Re: VPR'A'-7 WDW: Step Rate Test

VPR'A-7: Step Rate Test

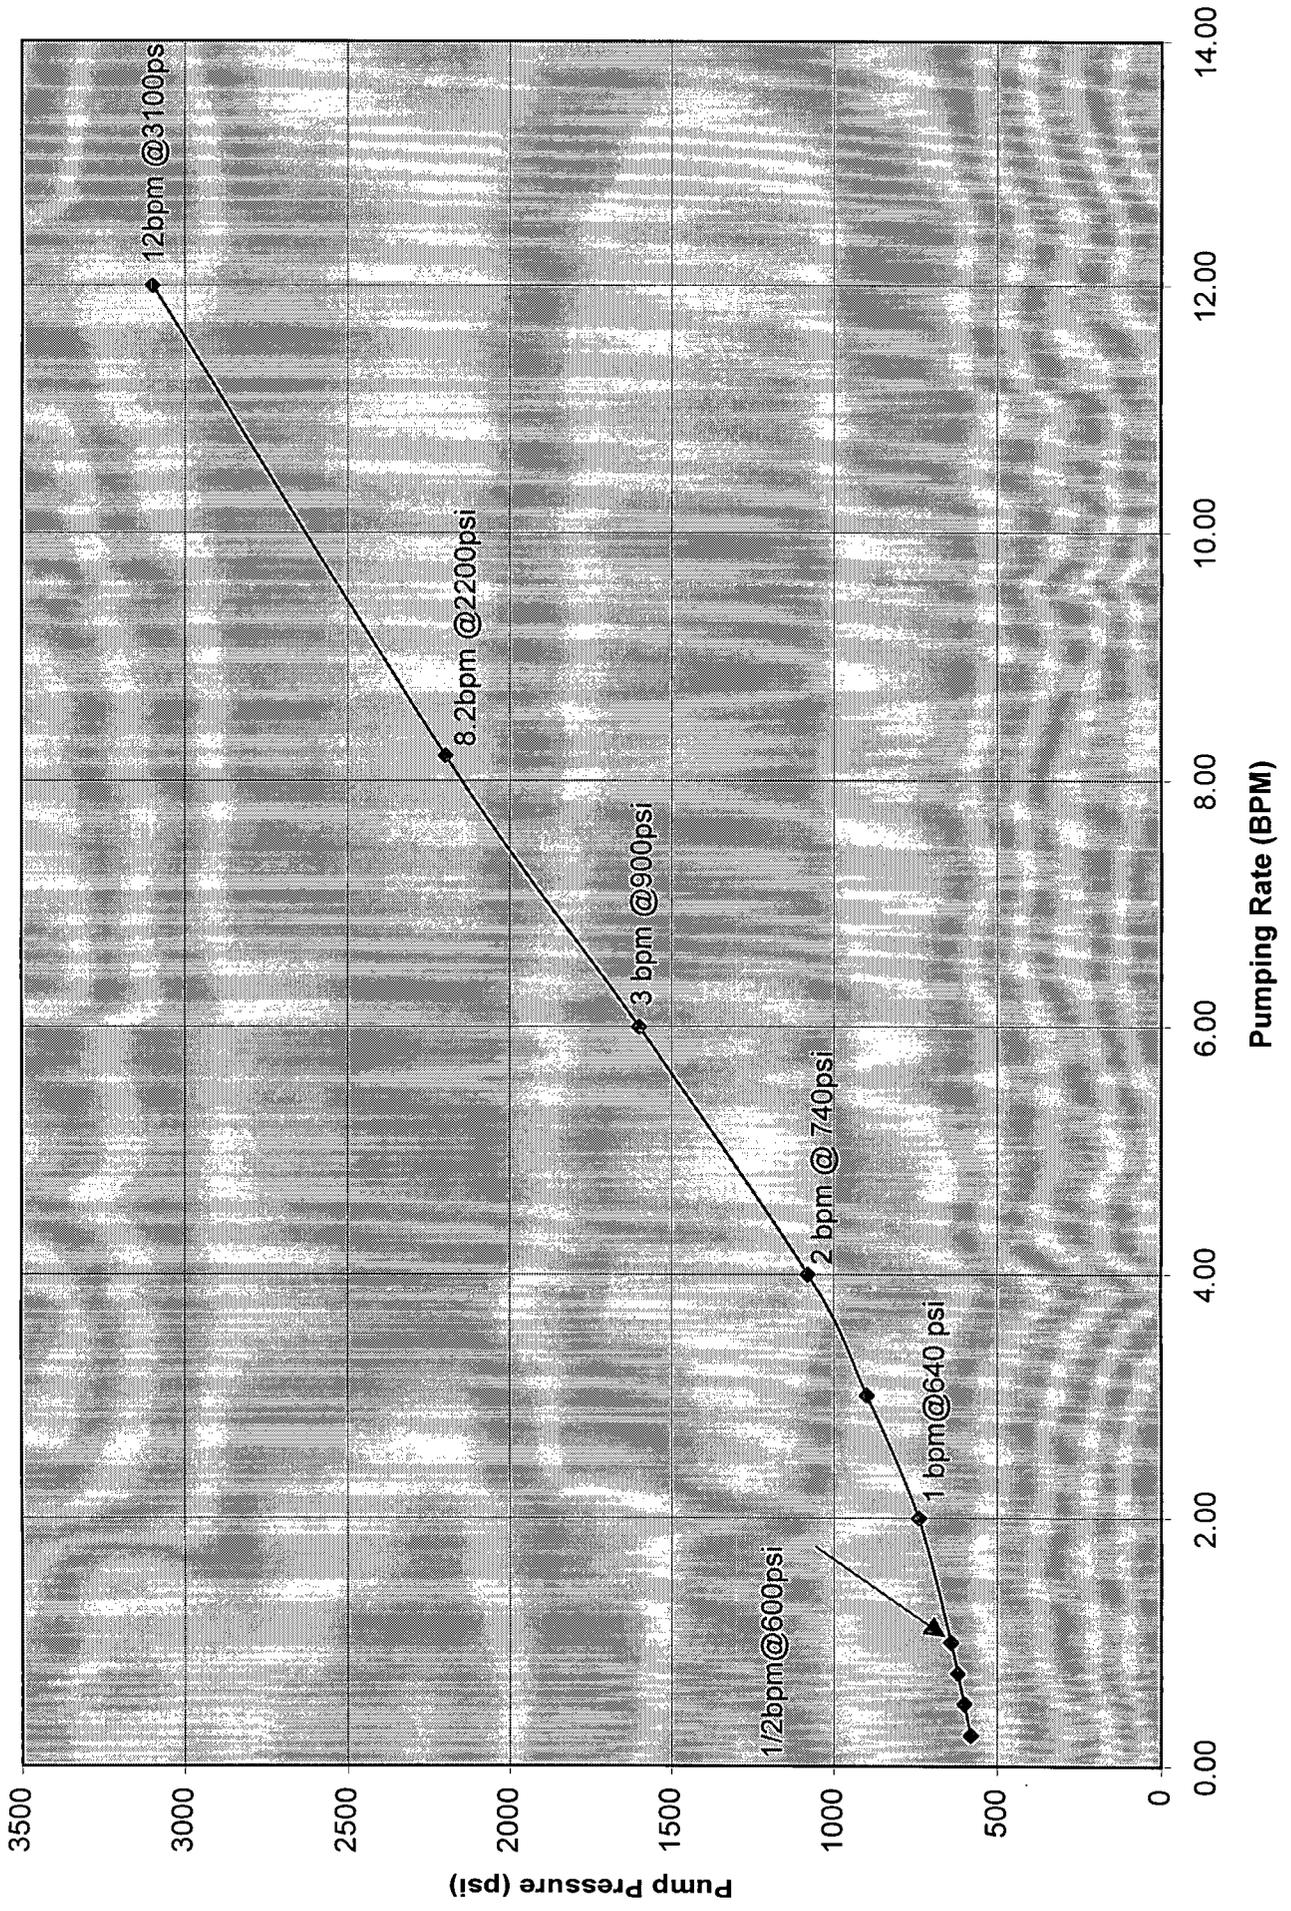
Values don't
match submit
re-submit

VPR'A'-7: Step Rate Test

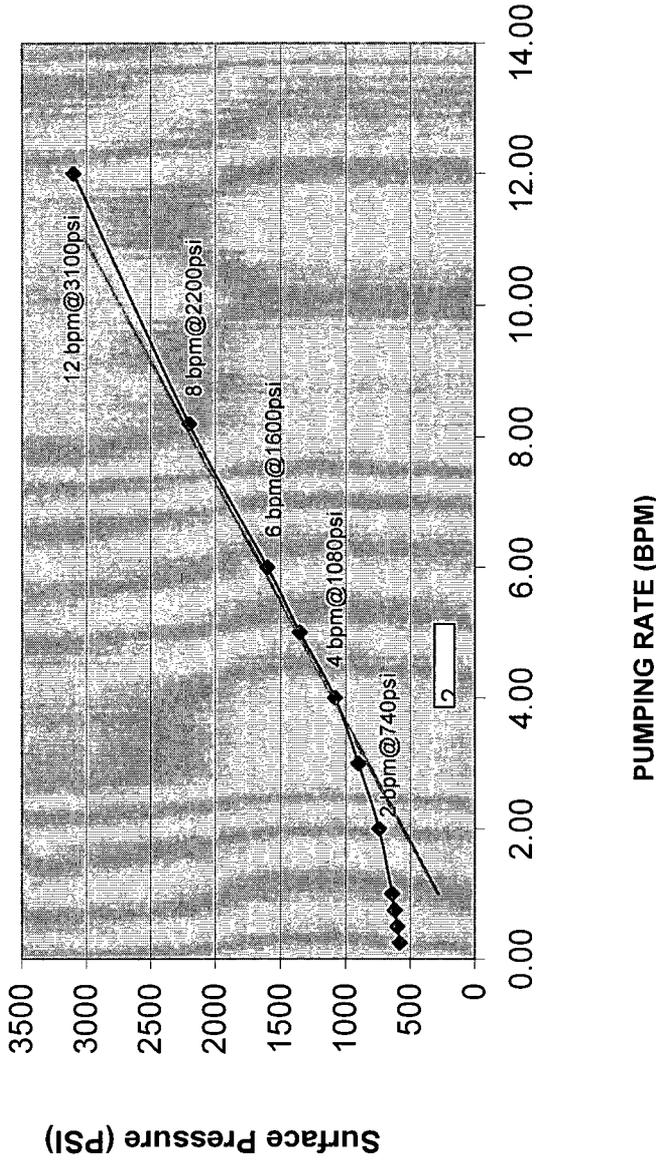
What -
 there was a break during the
 this test. The data may be
 fractured in this area thus
 giving us these types of results
 I think they are planning on
 additional sub well in this
 area @ the first of the
 year
 12/9
